# FRIENDS KNITTINGS LTD (EXTENSION)

19 February 2024

**Warehouse Building:** This is a seven-storied (G+6) RC building.

Approved Layout by Local Authority

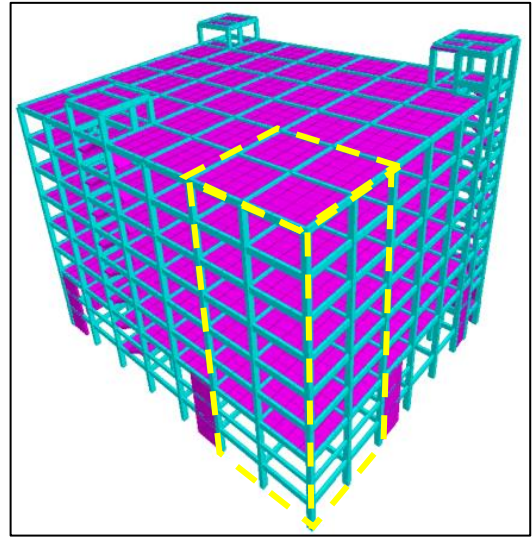
**Observation-1:** Inconsistency in the design documents.

**Description:** The marked portion at the local authority approved layout and a snapshot of the EA report has not been constructed yet. The yield strength of reinforcement has been considered as 72,500 psi, but from the rebar test report, it has been confirmed that lower-strength rebar was used in the construction of the building.

The building engineer is required to revise the EA report based on in-situ material strength and submit the EA documents to RSC for review. Also, prepare a set of as-built drawings for the as-built condition.
